Access Compliance Report

Public Rights-of-Way

(Curb Ramps)

Intersection ID: 10711	Main Street: EFFINGHAM_RD	Cross Street: TUCKASEEGEE_RD	Location: S
ADA ID: 1E004F97D164	Ramp Type: Perp	Initial Pass/Fail: Fail	Overall Compliance: No
		Severity Score: 12.5

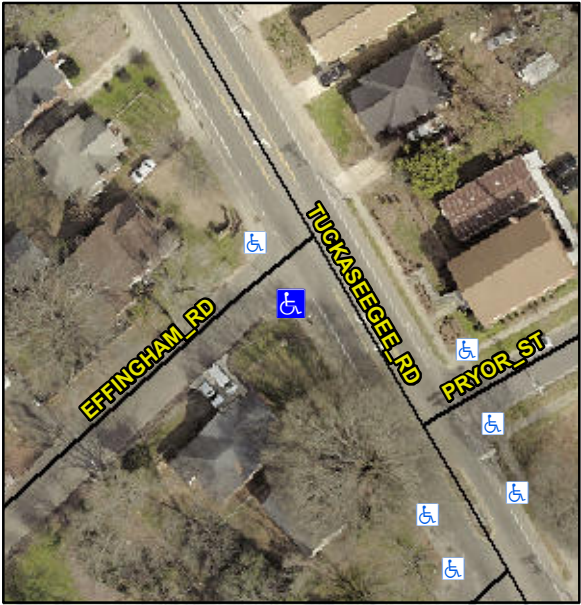
Codes/Mitigation Info/Possible Solution			Field Measurements/Component Compliance		
	Possible Solutions:		Compliance	Description	Data
	Remove & Replace Entire Ramp.		No	Ramp Length (in)	74.0
			Yes	Ramp Width (in)	48.0
			N/A	Flare Type LT	N/A
			N/A	Flare Slope LT (%)	N/A
			N/A	Flare Traversable LT?	N/A
			N/A	Landing Length (in)	N/A
			N/A	Landing Width (in)	N/A
			N/A	Landing Slope (%)	N/A
			N/A	Landing X Slope (%)	N/A
<p>Surveyor Notes:</p> <p>N/A</p> <p>PROW/ADA:</p> <p>Not Found, R304.2.2</p>			N/A	Flare Type RT	N/A
			N/A	Flare Slope RT (%)	N/A
			N/A	Flare Traversable RT?	N/A
			N/A	DWS Provided?	N/A
			N/A	DWS Contrast?	N/A
			N/A	DWS Length (in)	N/A
			N/A	DWS Full Width?	N/A
			N/A	DWS Offset (in)	N/A
			N/A	Shared Landing?	N/A
			N/A	Gutter Ponding?	Yes
<p>Street 1 Name</p> <p>Stop Condition-Street 2</p> <p>Street 2 Name</p> <p>Stop Condition-Street 1</p>			N/A	Gutter Lip Ht (in)	N/A
			N/A	Painted X Walk1?	No
